ORIGINATION FORM

Proposed Revisions to a Standard Plans Index

Index Number: 521-630

Index Title: PARAPET WITH C-I-P SIDEWALK - WALL COPING

TYPICAL SECTION THRU PRECAST COPING/PARAPET WITH C-I-P SIDEWALK AND RETAINING WALL (MSE Wall Shown, other Wall Types Similar)

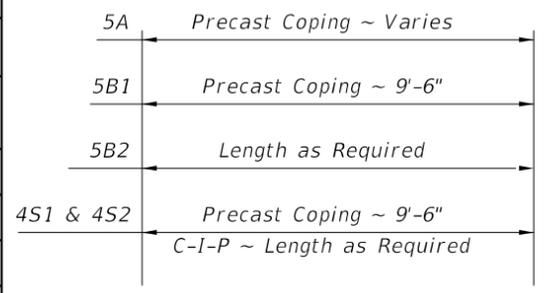
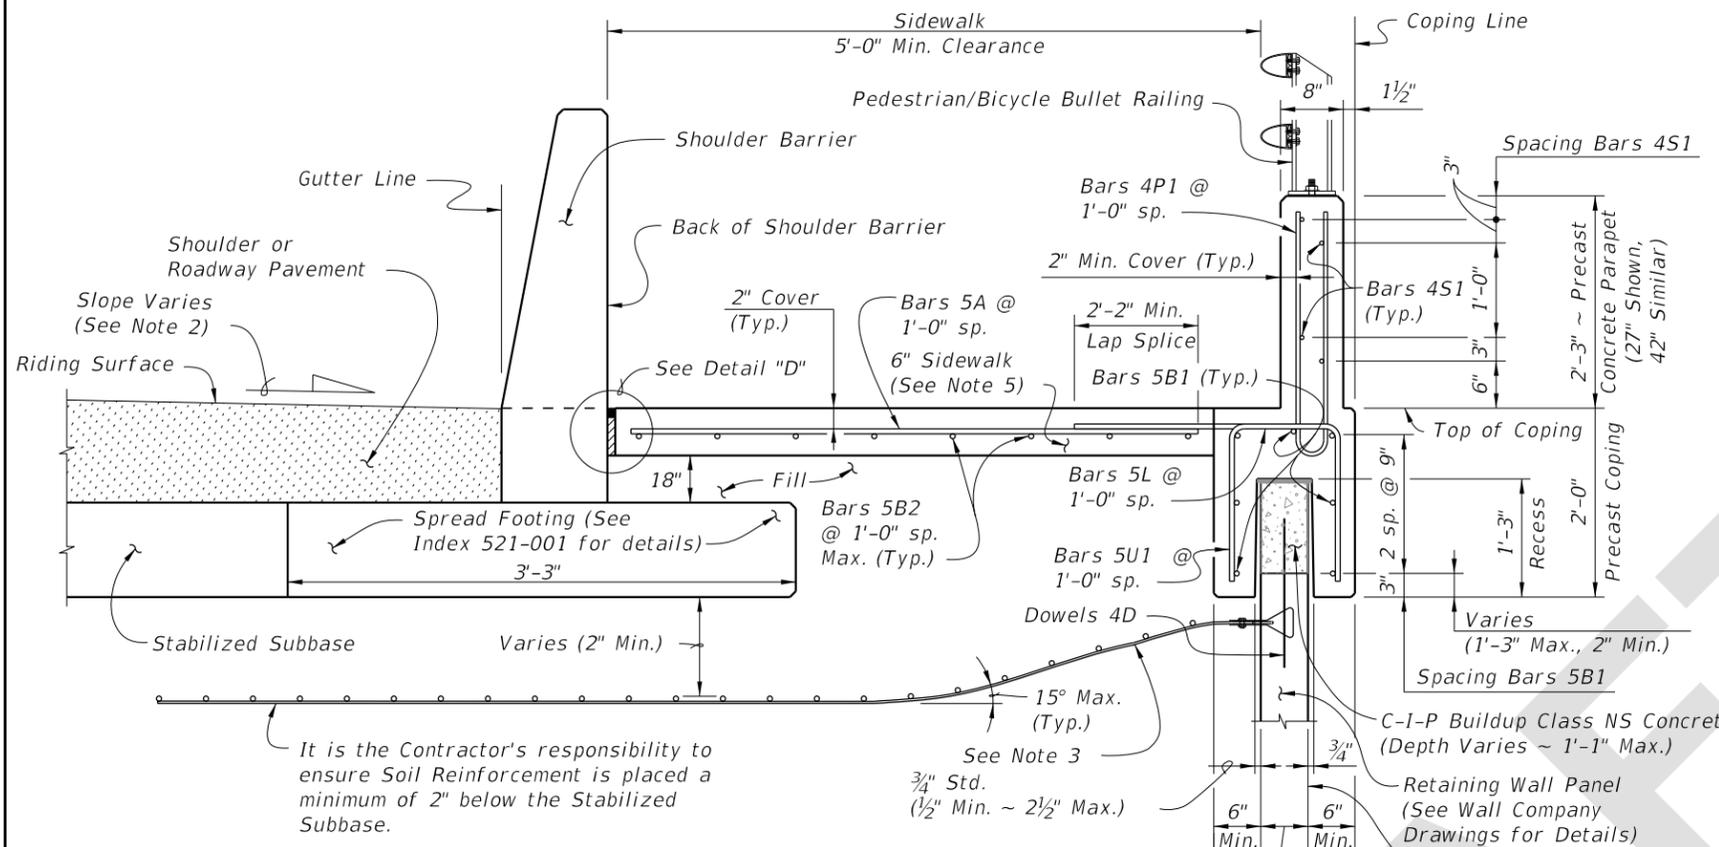
Changed footing depth below sidewalk to 18" from 10"; Updated the name of the barrier to Shoulder Barrier from Concrete Barrier Wall; Changed C-I-P Buildup Concrete (1'-1" Max.) callout in the TYPICAL SECTION THRU PRECAST COPING/PARAPET WITH C-I-P SIDEWALK AND RETAINING WALL to C-I-P Class NS Concrete (1'-1" Max.)

CHANGED DEPTH TO: 18"

UPDATED TO: Shoulder Barrier

CHANGED DEPTH TO: 18"

ADDED DIMENSION: 3'-3"

CHANGED TO: Class NS Concrete

CIP buildup concrete type was never clarified. SDO review deems Class NS is acceptable because the concrete buildup section is not meant to transfer any meaningful load to the wall other than self weight.
